City of Portland, Oregon
Bureau of Development Services
Land Use Services
FROM CONCEPT TO CONSTRUCTION

NOTICE OF A TYPE II DECISION ON A PROPOSAL IN YOUR NEIGHBORHOOD

CASE FILE NUMBER: LU 19-209183 DZM – PATIO IMPROVEMENTS

C-2

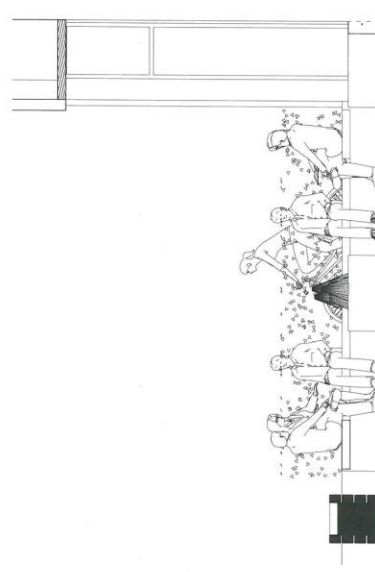
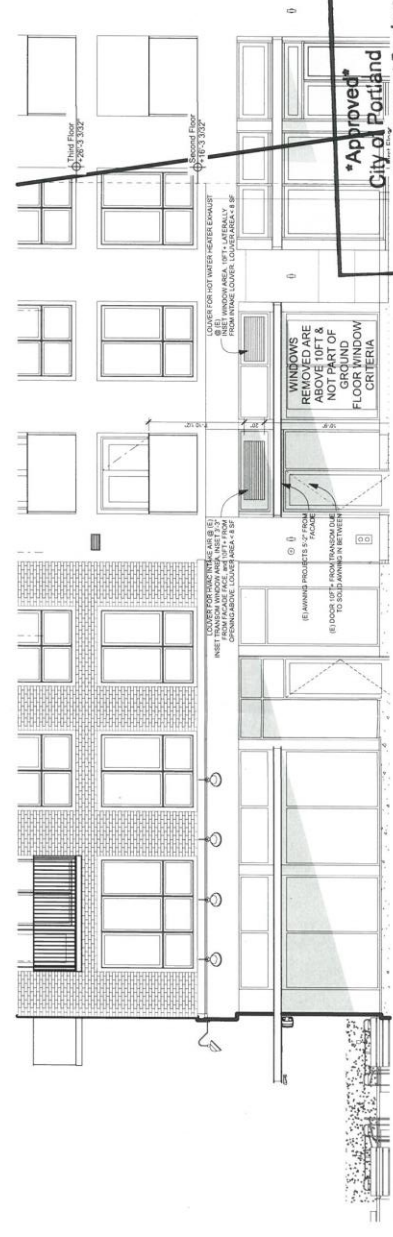
Findings for D1, D2, and D3: As is noted above, the patio area was previously established, and this review is for the new permanent elements, including wood benches and a fire pit, that will ensure its use. The drawings show that the bench is proposed to extend across an already defined and constructed pathway leading from the pedestrian accessway to an entrance, which is an inappropriate extension, severing the connection between the patio and the pedestrian accessway. Because this pathway is intended to provide a connection from the pedestrian accessway to the building, staff has added a condition that the bench shall not extend across the pathway marked by the existing concrete planters and the lighter concrete paving. This will ensure that this entrance remains accessible for pedestrians coming from the pedestrian accessway.

With the condition that the bench shall not extend across the pathway marked by the existing concrete planters and the lighter concrete paving, these guidelines are met.

Findings for 7A and 7D: The existing patio area was designed to provide connections between the pedestrian accessway and side entrance to this retail space. The drawings show this connection to be severed by extension of the bench across this pathway. While the overall proposal to install permanent elements such as the benches and firepit will help to activate this space, severing this connection does not meet the aspects of these guidelines which speak to linking adjacent open spaces and ensuring pedestrian connections. Therefore, staff has added a condition that the bench shall not extend across the pathway marked by the existing concrete planters and the lighter concrete paving.

- A. As part of the building permit application submittal, the following development-related conditions (B through D) must be noted on each of the 4 required site plans or included as a sheet in the numbered set of plans. The sheet on which this information appears must be labeled "ZONING COMPLIANCE PAGE - Case File LU 19-209183 DZM." All requirements must be graphically represented on the site plan, landscape, or other required plan and must be labeled "REQUIRED."
- B. At the time of building permit submittal, a signed Certificate of Compliance form (<https://www.portlandoregon.gov/bds/article/623658>) must be submitted to ensure the permit plans comply with the Design/Historic Resource Review decision and approved exhibits.
- C. No field changes allowed.
- D. The bench shall not extend across the pathway marked by the existing concrete planters and the lighter concrete paving.
